WIEDEMANN BUSINESS PARK COMMUNITY UNIT PLAN DP-88

MAPC Admin Adjustment 6/10/2022
2 of 4 CUP 22-29

RE: CUP2022-00029 – City CUP Adjustment to Wiedemann Business Park Community Unit Plan CUP DP-88 to adjust parcel sizes on property zoned GC General Commercial, located on the south side of East Kellogg Drive, within one-quarter mile west of South Greenwich Road.

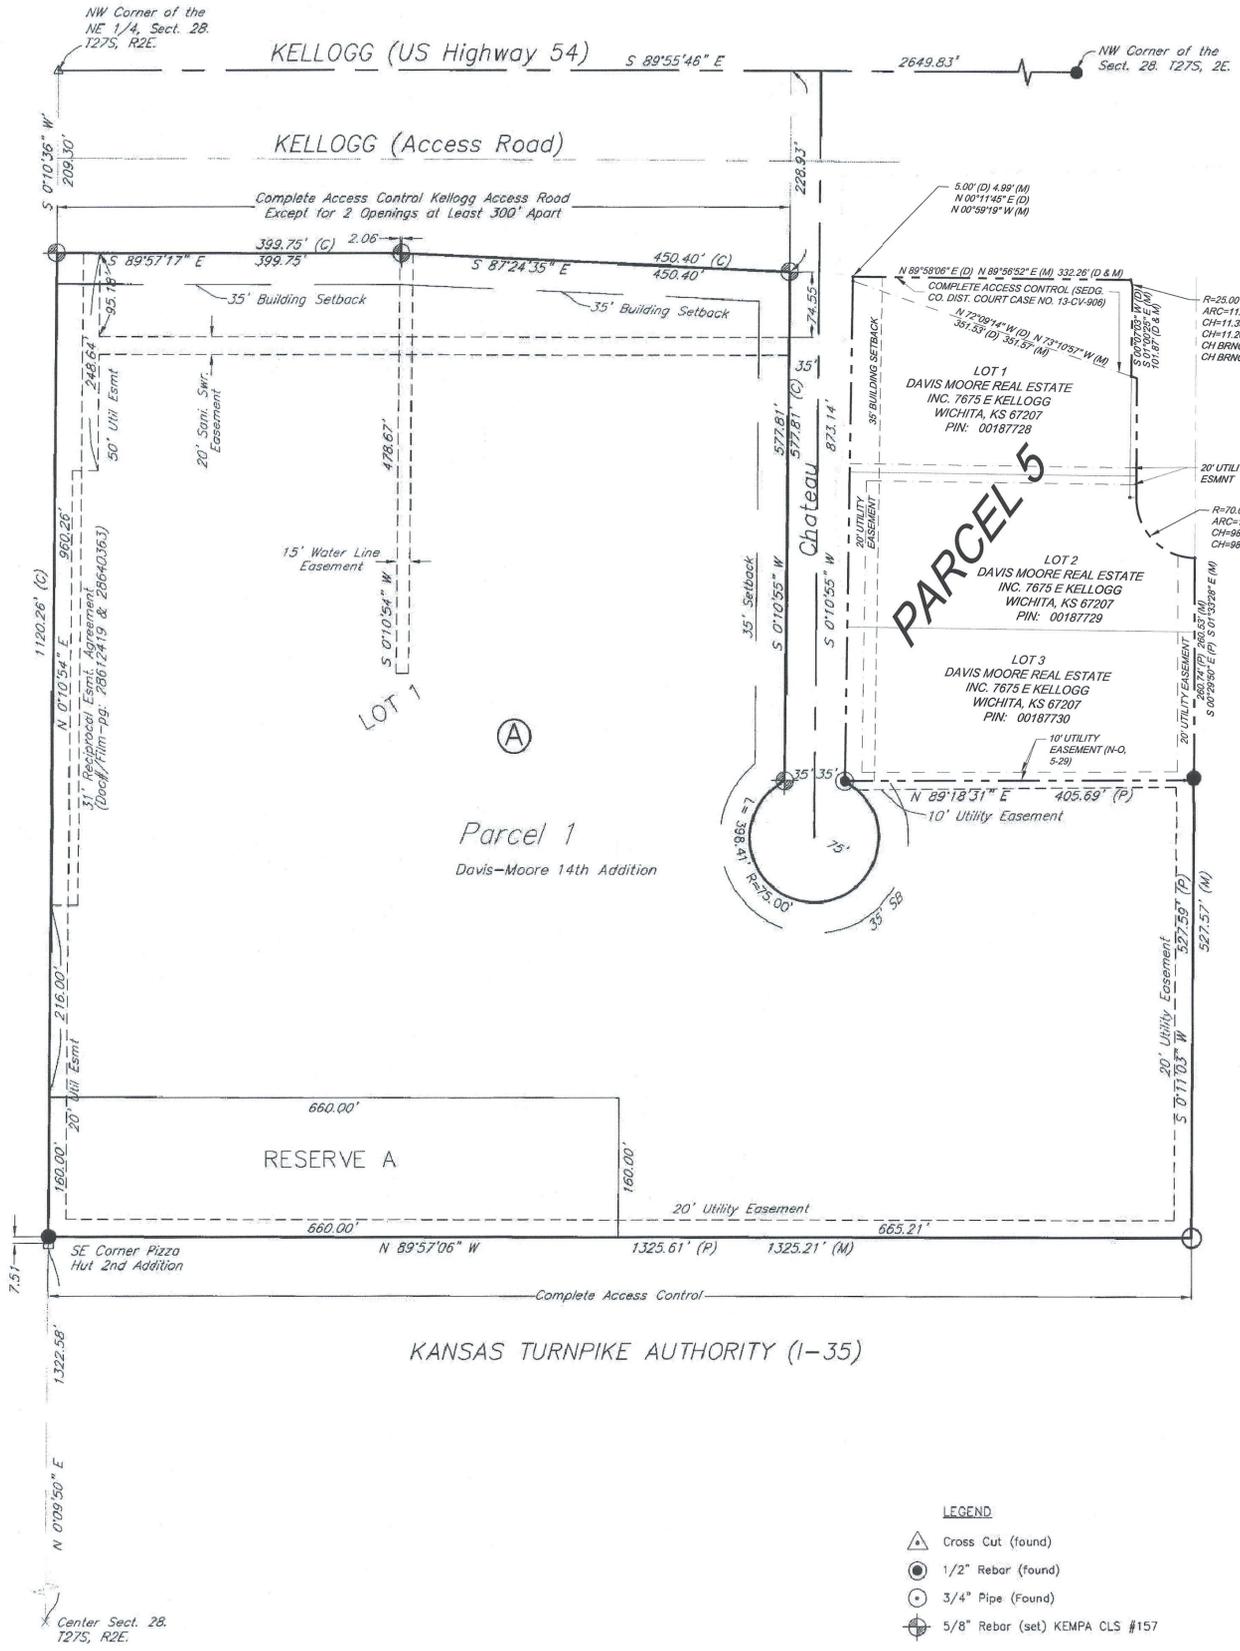
We received and reviewed your request for an Administrative Adjustment to DP-88 to alter the parcel boundary and area calculations of Parcel 5. Upon review of the Community Plan General Provision, staff found additional adjustments to outdated terminology that needs to be included in this adjustment. The following reflects the proposed modifications identified in red letters:

Parcel 5:

Permitted Uses: Same as Parcel 1
Floor Area Ratio: 45% or **99,558 sq. ft.**; 50% or **110,620 sq. ft** for warehousing or wholesale distribution.
Maximum Building Height: 35 Feet
Area = **5.08 Acres**

General Provisions:

#7: Screening and Landscaping: A landscaped street yard adjacent to the Kansas Turnpike shall be provided with trees, grass and shrubbery not less than ten (10) feet in width, and otherwise in compliance with the landscape ordinance. Failure to maintain the landscape street yard shall be considered a violation of the C.U.P. after a joint determination by the Director of Planning and **the Zoning Administrator.**
~~Superintendent of Central Inspection.~~

A performance bond shall be posted with the **Zoning Administrator** ~~Superintendent of Central Inspection~~ guaranteeing the present cost of wall construction adjusted for inflation over a ten (10) year period...
